UNITED STATES PATENT AND TRADEMARK OFFICE

APPLICATION NO.	FILING DATE	FIRST NAMED INVENTOR	ATTORNEY DOCKET NO.	CONFIRMATION NO.
10/522,507	01/17/2006	Igor Pereverzev	19339-100309	3456

Office Action Summary	Application No. 10/522,507	Applicant(s) PEREVERZEV, IGOR	
	Examiner Kristina R. Fulton	Art Unit 3673

DETAILED ACTION

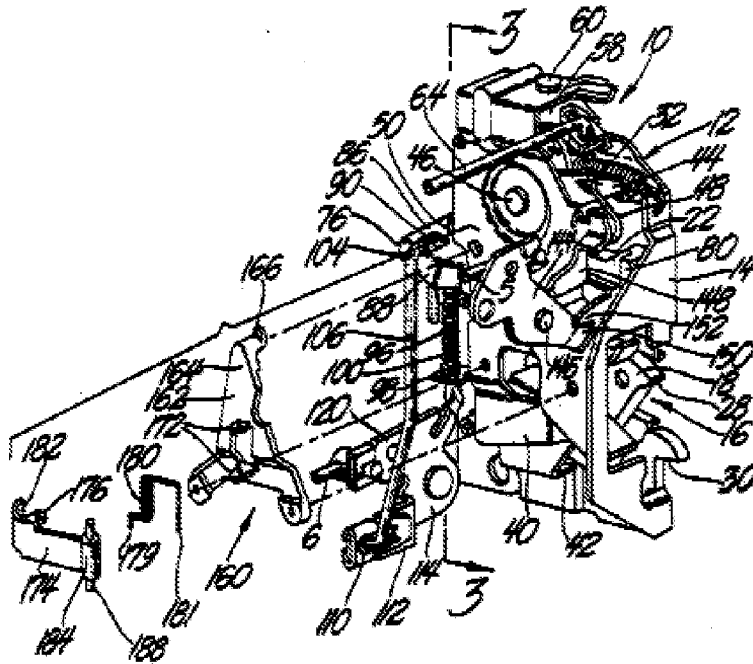
7. Regarding claim 1, Lee shows a latch mechanism for selectively latching a door to an automotive vehicle, said latch mechanism comprising a latch hook (18) movable between a locked position and an unlocked position, a release lever (76) operatively coupled to said latch hook for selectively moving said latch hook between said locked and unlocked positions; and an inertia lever (174) engageable with said release lever to prevent movement of said latch hook between said locked and unlocked positions, said inertia lever movably supported within said latch mechanism for moving in and out of engagement with said release lever in response to a side impact upon the vehicle (causing a change acceleration/deceleration); wherein said release lever includes a slot

presenting sides for engaging a portion of said inertia lever for automatically toggling said inertia lever in response to movement of said release lever to prevent seizing of said inertia lever within the latch mechanism. See the Lee device below.

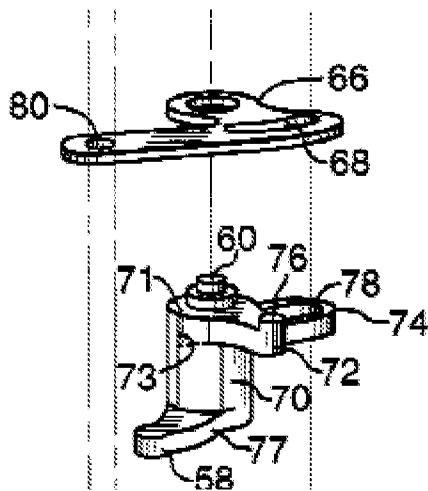
8. Regarding claims 1, 3-4 and 5-6, Lee shows that the inertia lever (174) blocks the release lever (76) via tab (182). Lee fails to teach that this tab is in a slot of the release lever. Cetnar shows that it is very well known in the vehicle latch art to include a tab and slot engagement. Cetnar shows that tab (76) is received in slot (68). It would have been obvious to one of ordinary skill in the art to include a slot as taught by Cetnar on the release lever of Lee for engagement with tab (182) in order to assure proper alignment of the levers throughout complete motion of the inertia lever relative to the release lever. See the Cetnar device below.
